## 1. KIT FOR CHANGING THE ROTATION OF THE LOOM, CLOCKWISE TO COUNTER CLOCKWISE

Below is a short description of how to change the direction of rotation from CW to CCW of the HM604 loom. Combined with the standard manual for the loom, it is a task that can be done inhouse with own technician.

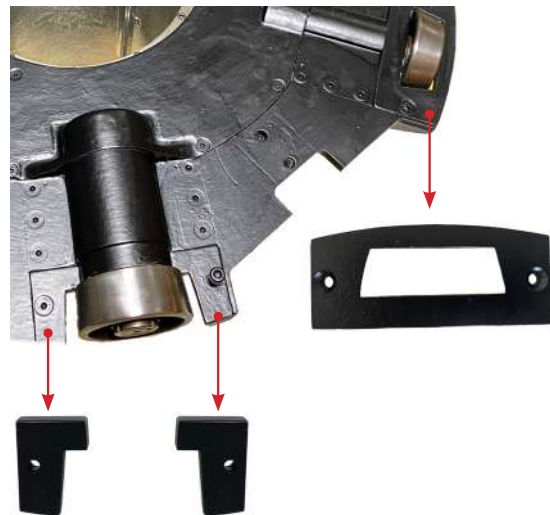
The support thrust wheels (front and rear) change position

These brackets must also change position (follow the support thrust wheels)

When you move and flip the brackets, you should countersink the hole for the screw

**The Counter clockwise Drive.  
 (the gear is not shown in this  
 picture) is mounted below the  
 <D> gear.**
